ALLAMAKEE CSD MIDDLE SCHOOL HVAC UPGRADE
WAUKON, IOWA

ADDENDUM 02
March 6, 2026

ELECTRICAL PLAN - OVERALL

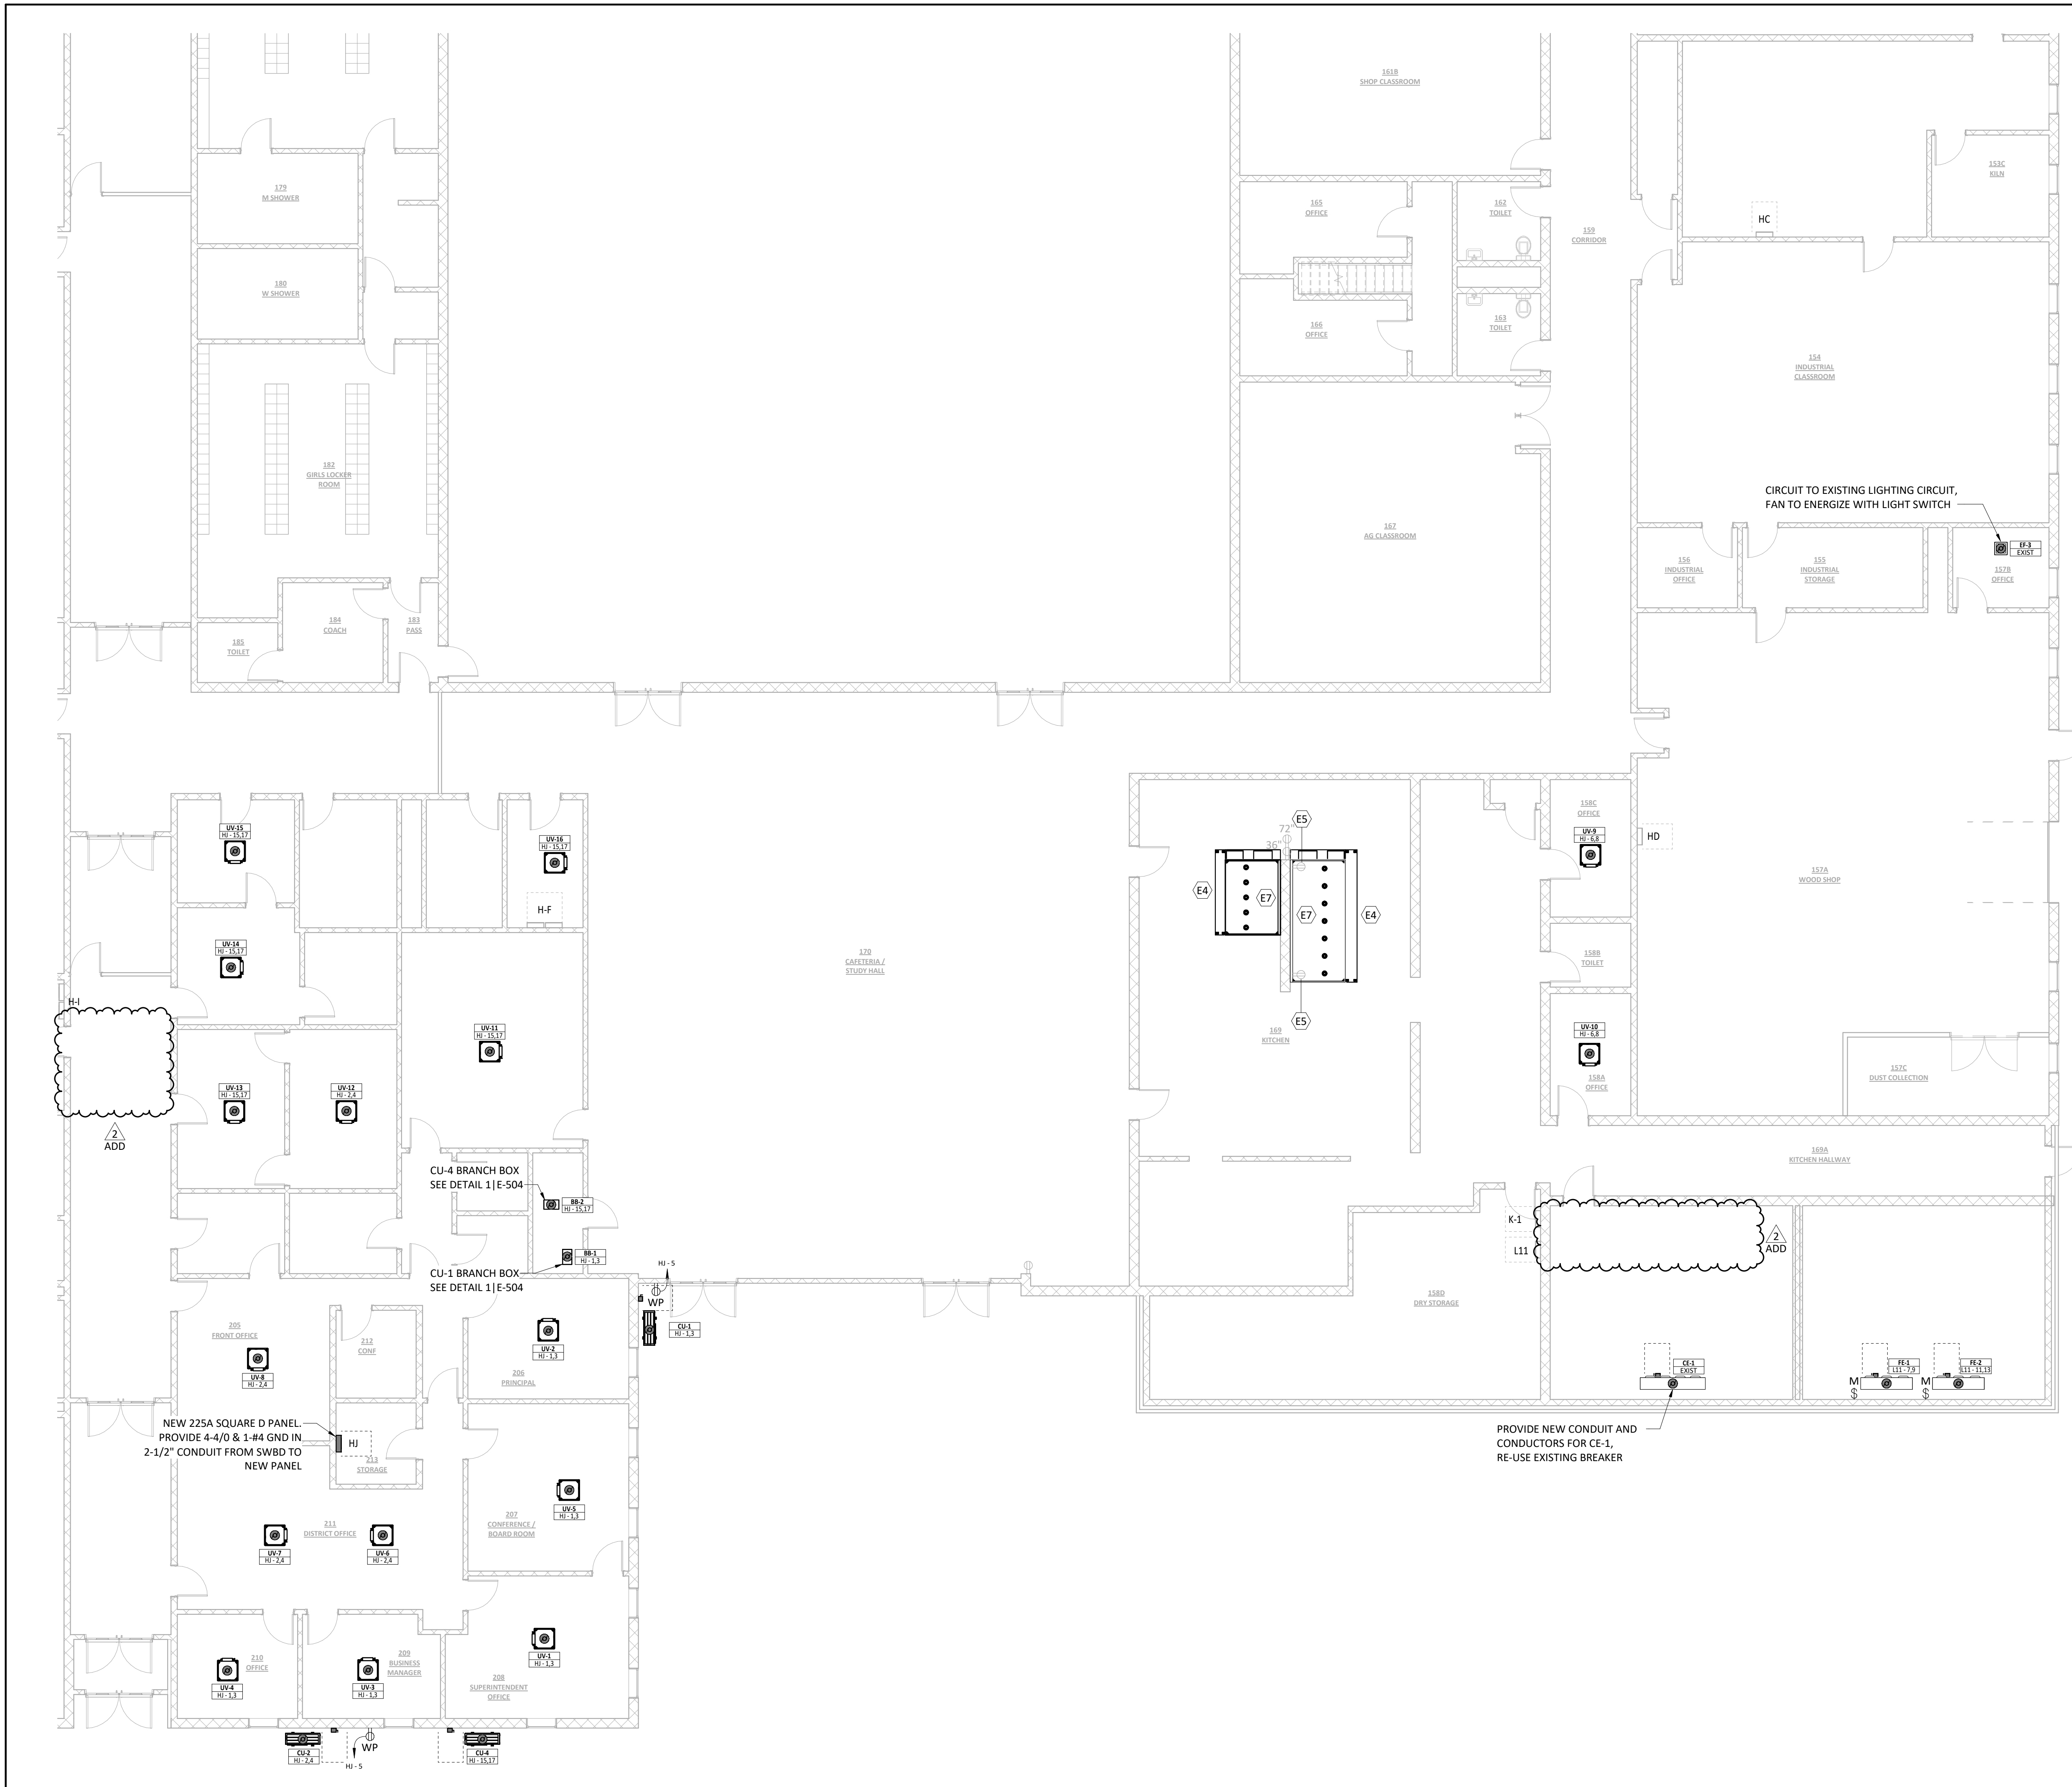
3. Added note for new ACT ceiling.
- E2-1 Drawing **E-101 – ELECTRICAL PLAN – OVERALL**
1. Added keynote for providing temp and emergency power for ICN and district IT rooms.

SHEET NAME
ELECTRICAL PLAN - AREA B

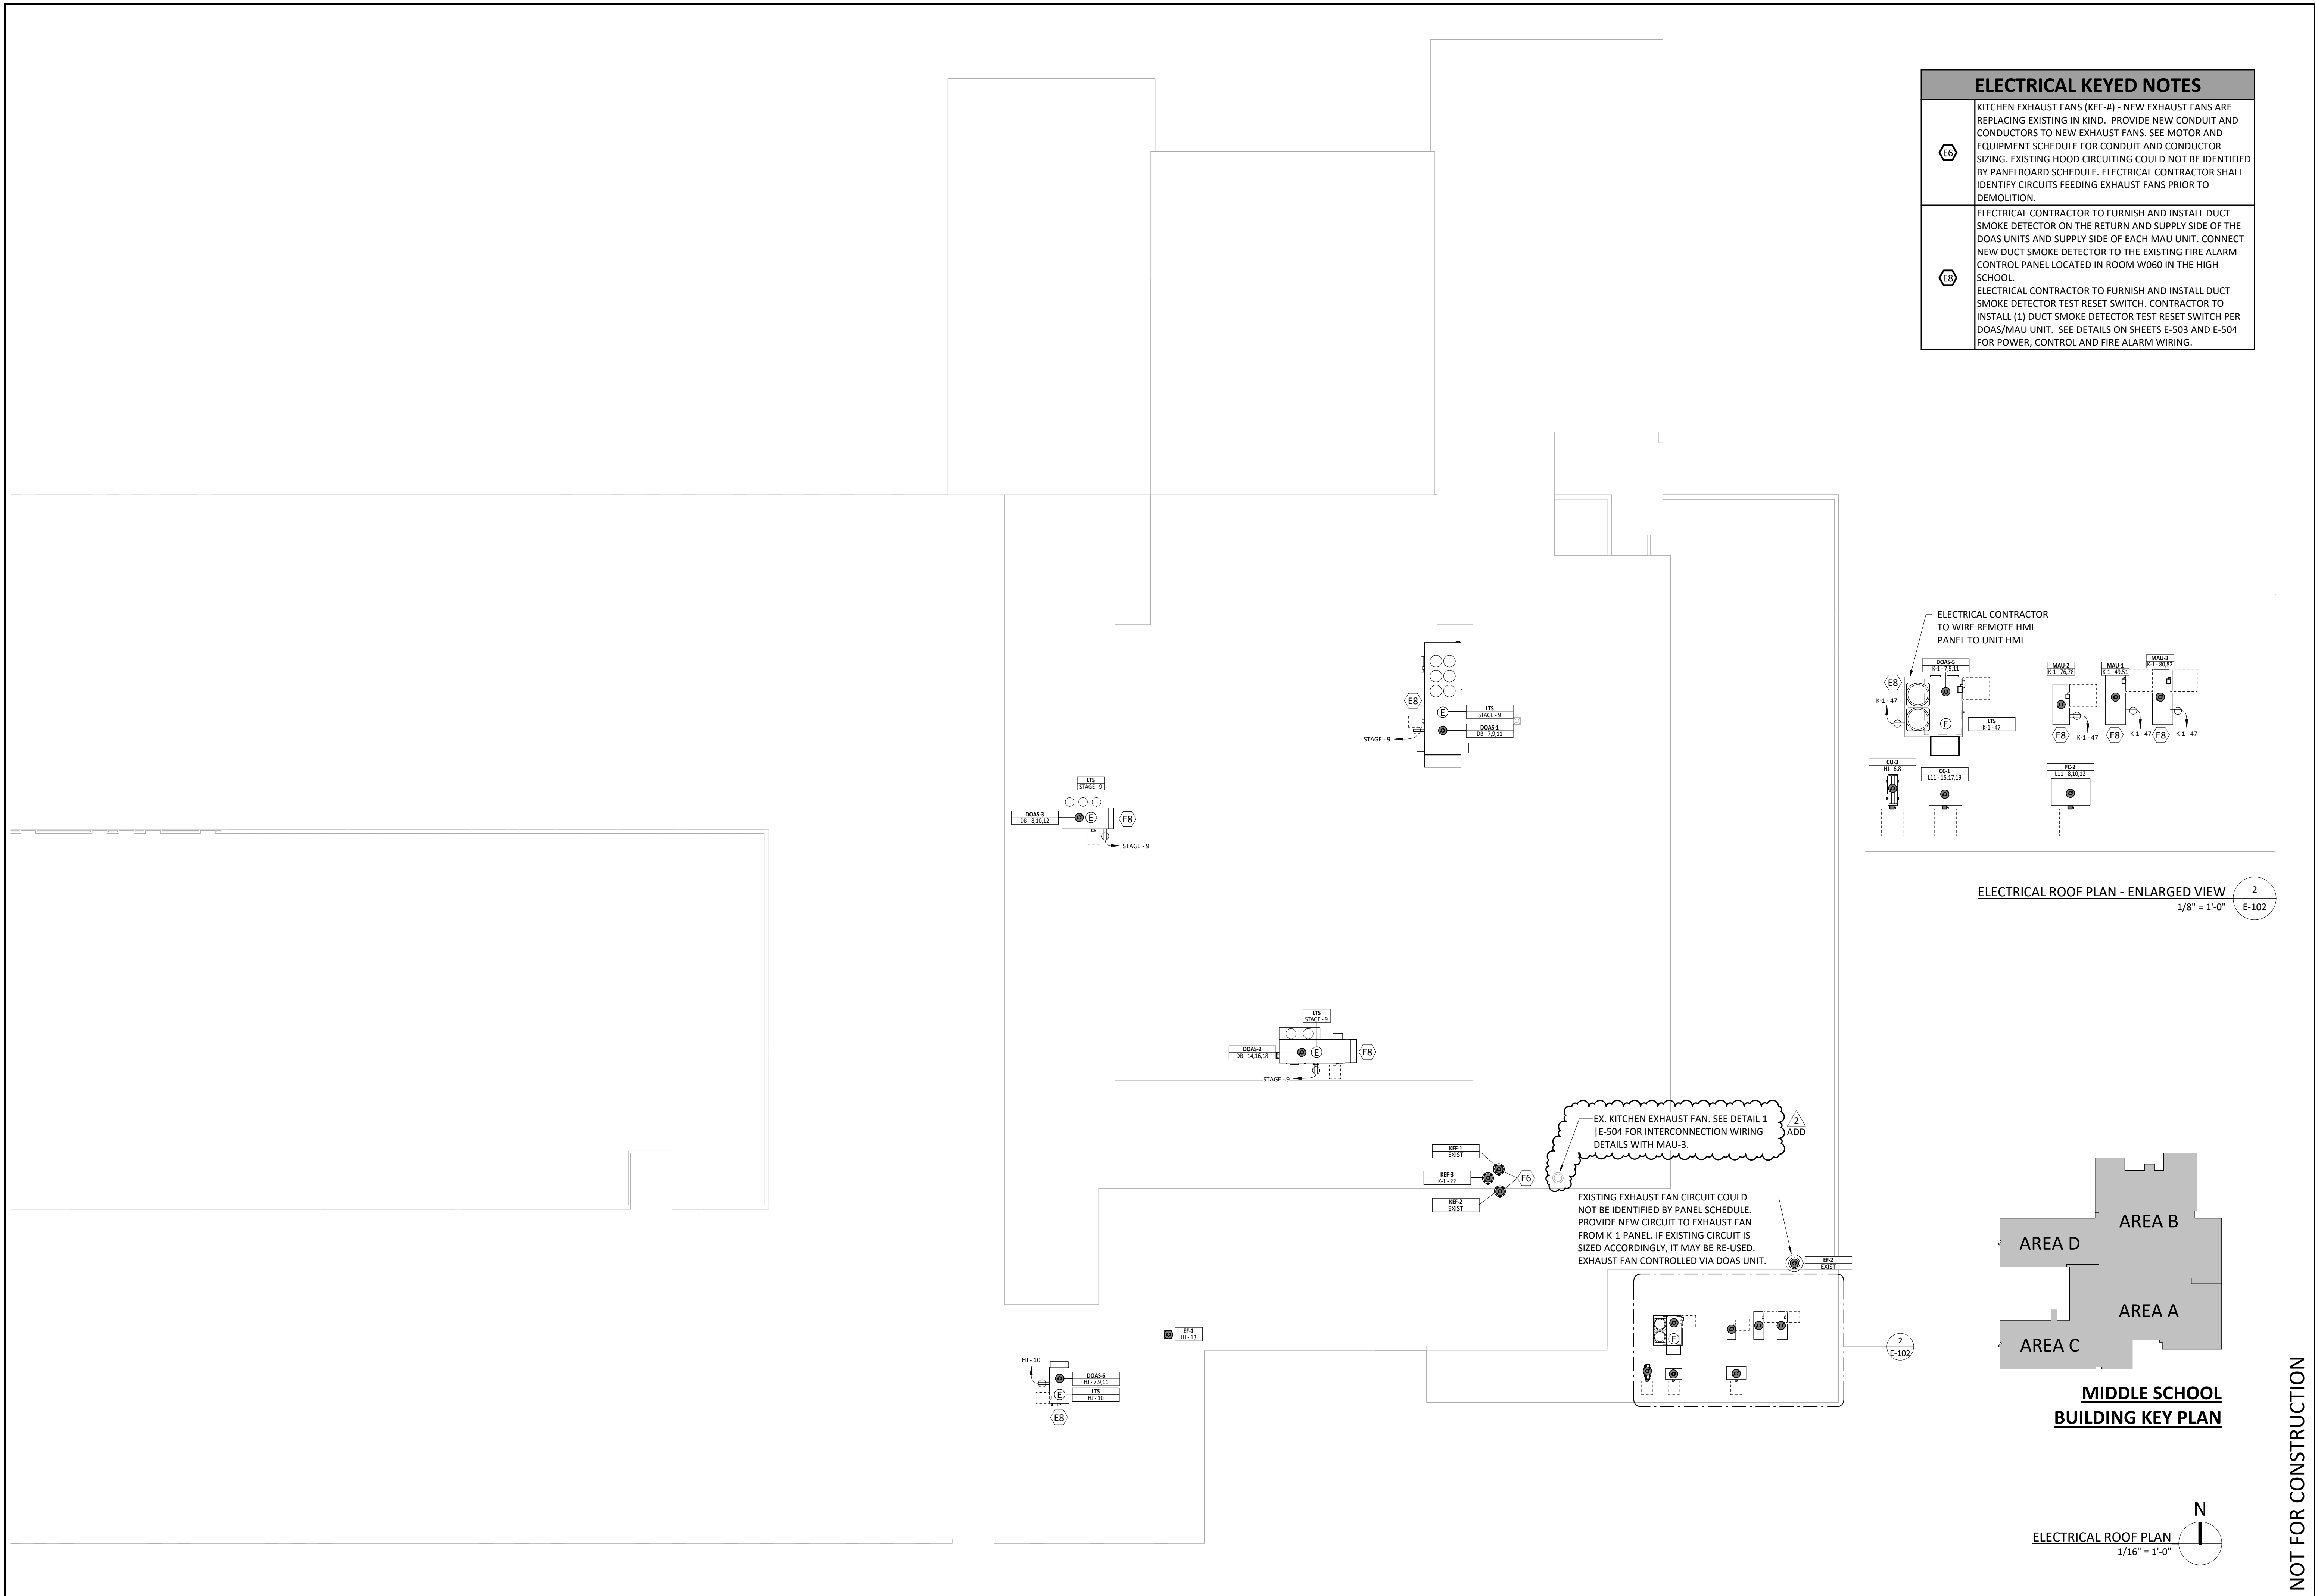
1. Added circuiting to circulator pumps for DOAS unit.

ELECTRICAL ROOF PLAN - ENLARGED VIEW 2
1/8" = 1'-0" E-102

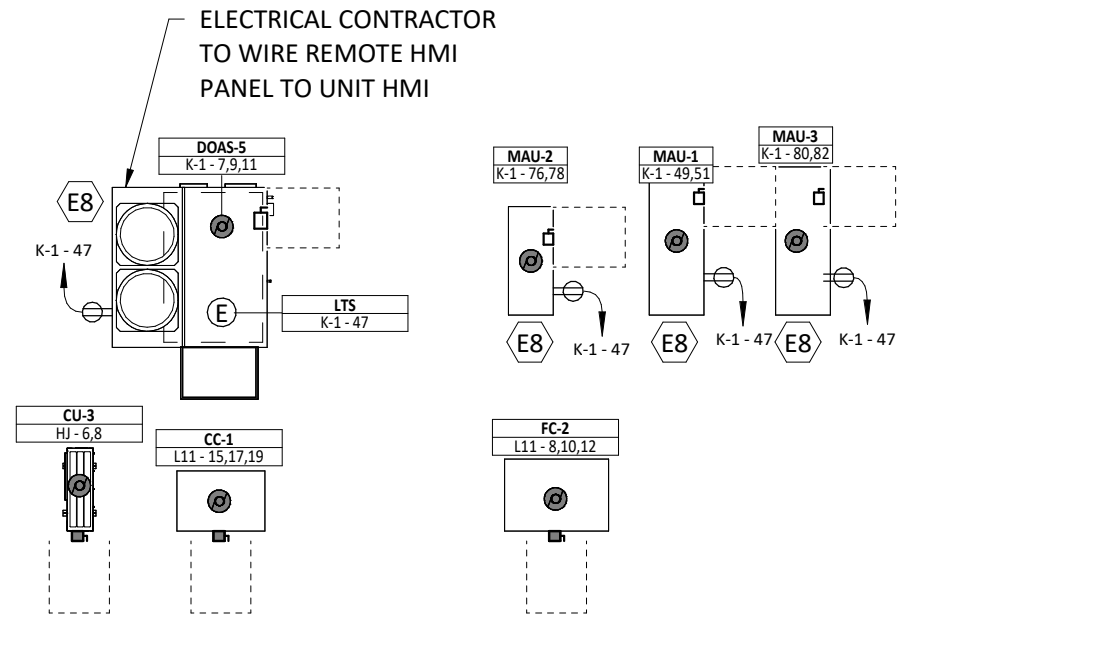
- E2-4 Drawing **E-102 – ELECTRICAL ROOF PLAN**
 1. Added note referencing detail for existing kitchen exhaust fan.
- E2-5 Drawing **E-110 – LIGHTING PLAN – OVERALL**
